Re: Revised Closure Permit Application for the Plant Gorgas Bottom Ash Landfill

**PERMIT APPLICATION FOR CCR LANDFILL
PLANT GORGAS BOTTOM ASH LANDFILL
PARRISH, ALABAMA
ALABAMA POWER COMPANY**

DRAWING TITLE	
POTENTIOMETRIC SURFACE CONTOUR MAP OCTOBER 7, 2019 PLANT GORGAS BOTTOM ASH LANDFILL	
FIGURE NO	FIGURE 6
Southern Company

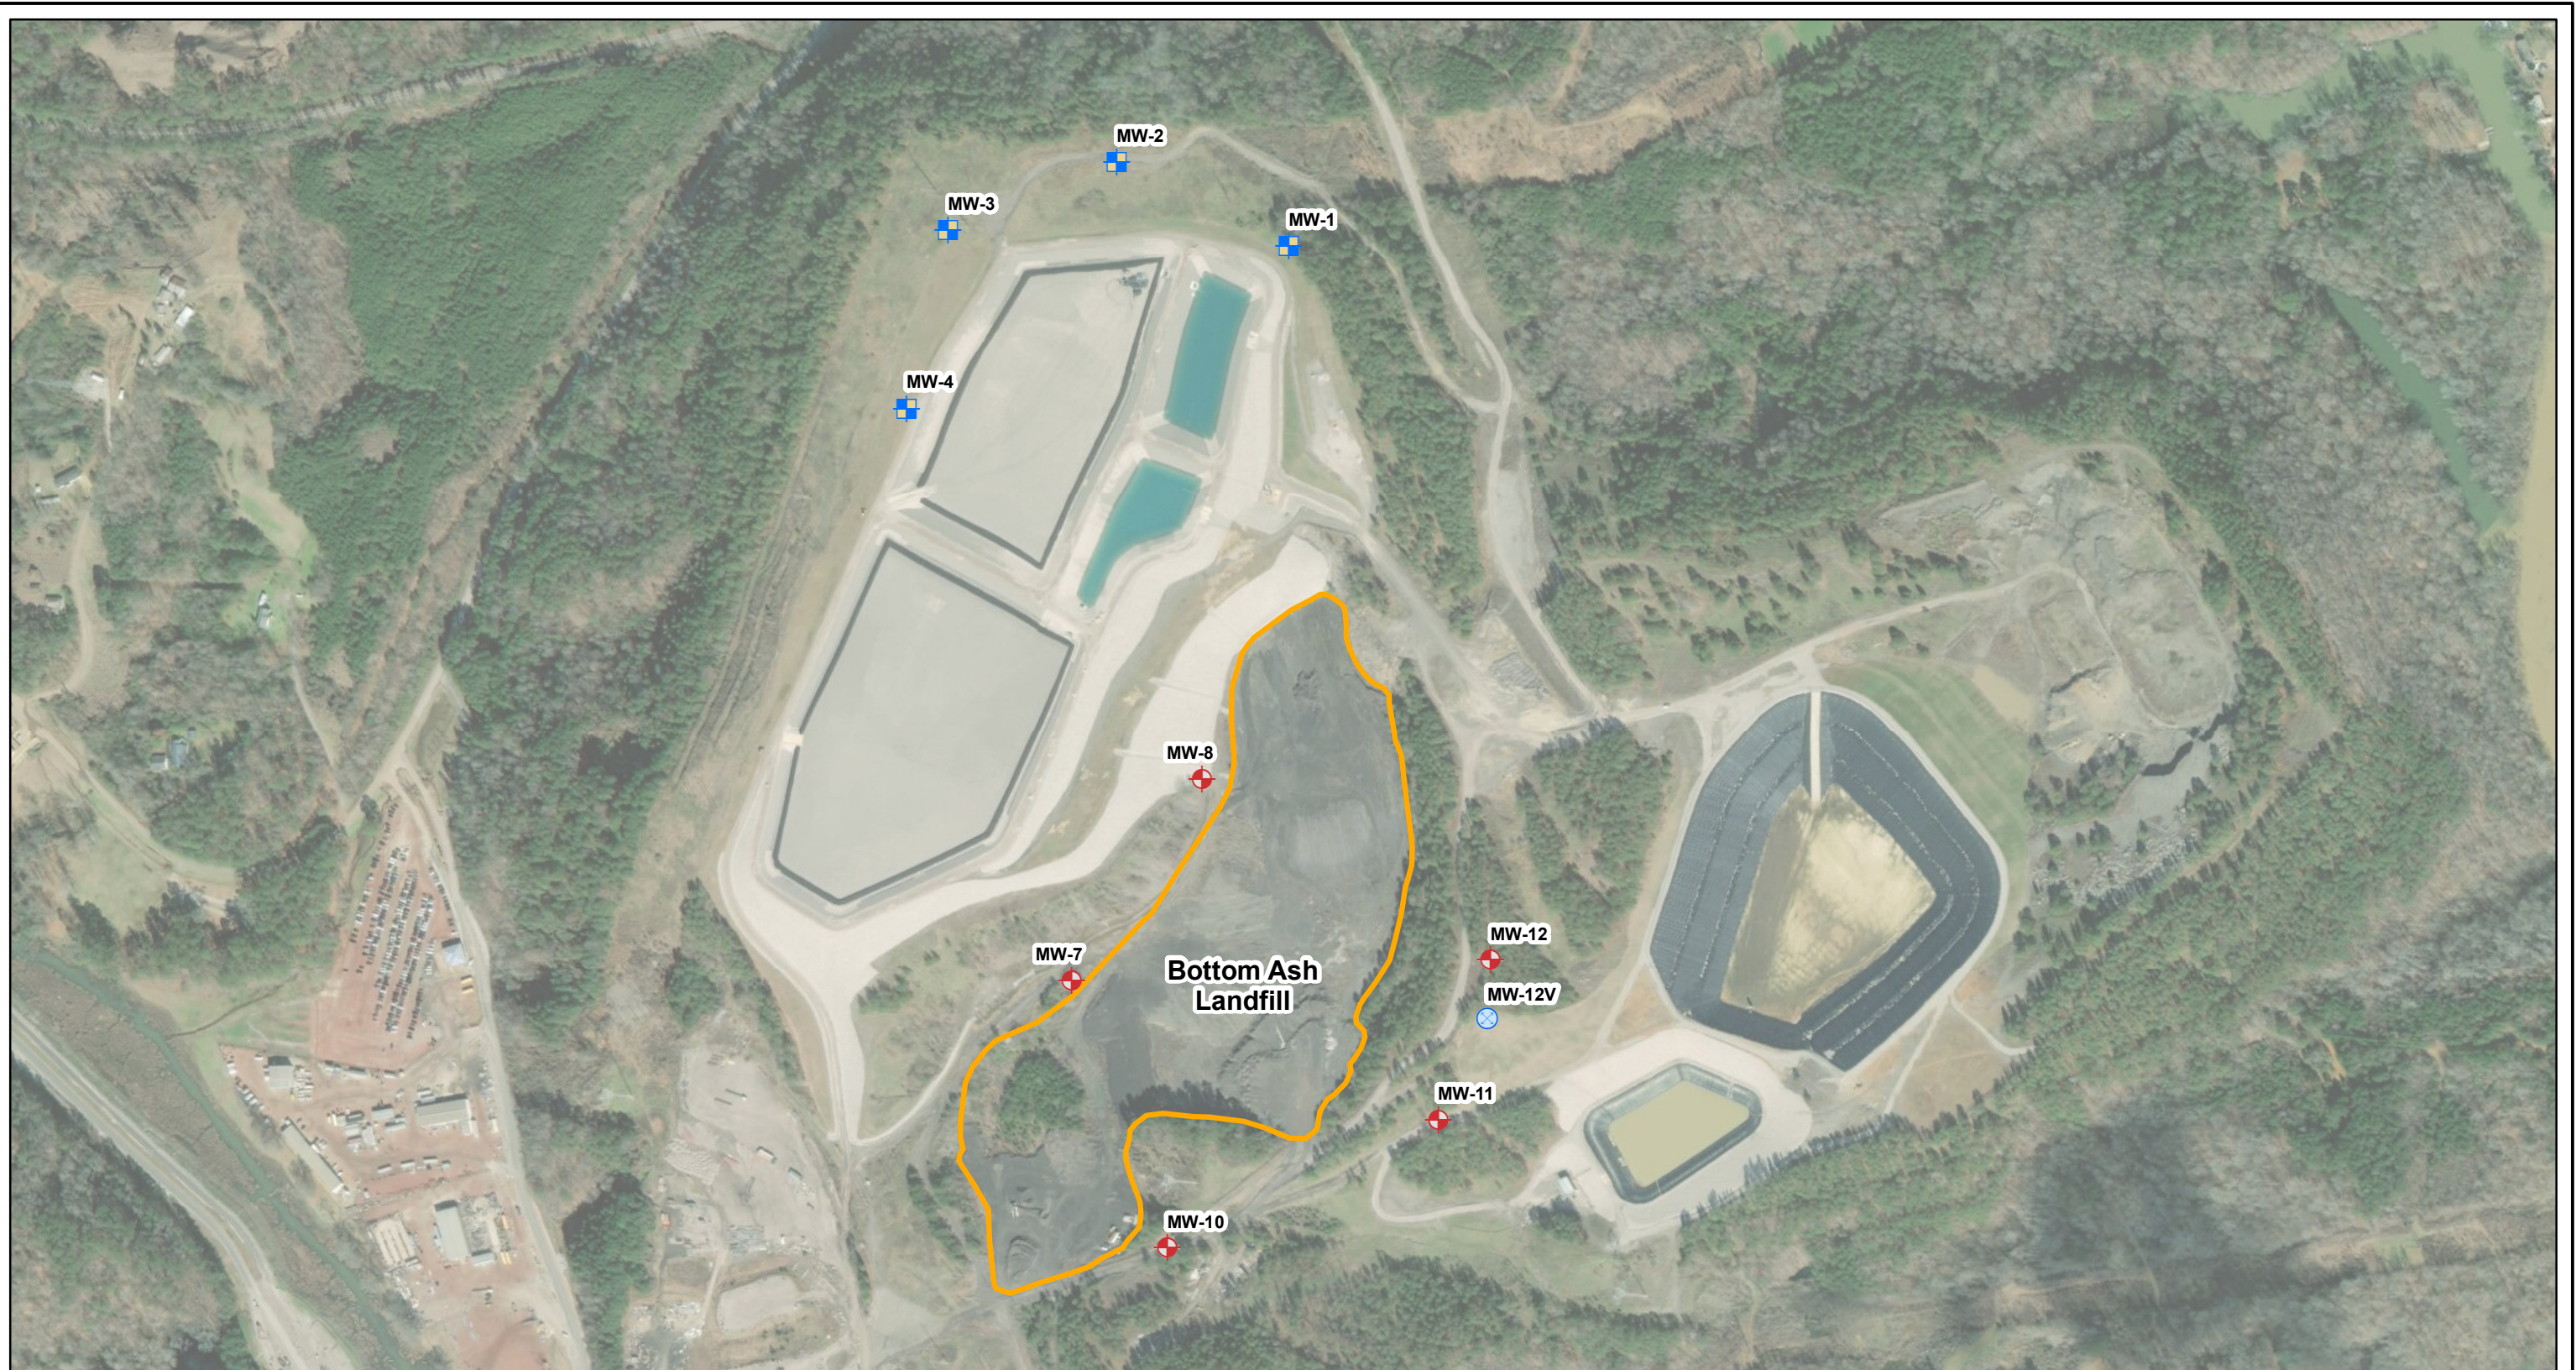
- 3. It appears that monitoring wells should be installed to monitor the (deep) Pratt Aquifer downgradient of the waste management unit between GS-AP-MW-15 and GS-AP-MW-25H in topographic low areas of the drainage feature depicted west of the site on Figure 6A.*

As requested by the Department, the figures and tables of the GWMP will be updated to identify current and planned wells so the monitoring network is sufficiently described for permitting purposes. Since submission of the GWMP to the Department, additional wells have been installed within the (deep) Pratt Aquifer. As presented on Figure 5 in the *2020 Annual Groundwater Monitoring and Corrective Action Report*, dated January 31, 2021, wells GS-AP-MW-37H and GS-AP-MW-39H were installed as part of delineation efforts at the site. However, as often occurs in the Pratt Aquifer, significant groundwater-bearing zones were not encountered, and the wells yielded insufficient groundwater for sampling. Also shown on Figure 5 are the locations of 4 wells that were abandoned pursuant to Department approval to facilitate pond closure work. These 4 wells are to be reinstalled when construction permits. A workplan and proposed replacement locations will be submitted to the Department by March 31, 2021. Well GS-AP-MW-12 remains in that area and is sampled semi-annually. Arsenic concentrations have steadily decreased in well GS-AP-MW-12 from 0.11 milligram per liter in August 2016 (mg/L) to 0.00616 mg/L during the most recent sampling event in September 2020. Concentrations have been below the GWPS during the last two sampling events. This steady decrease from the initial sampling event fits the description of chemical equilibrium restoring after the initial disturbance generated from the boring and well installation process.
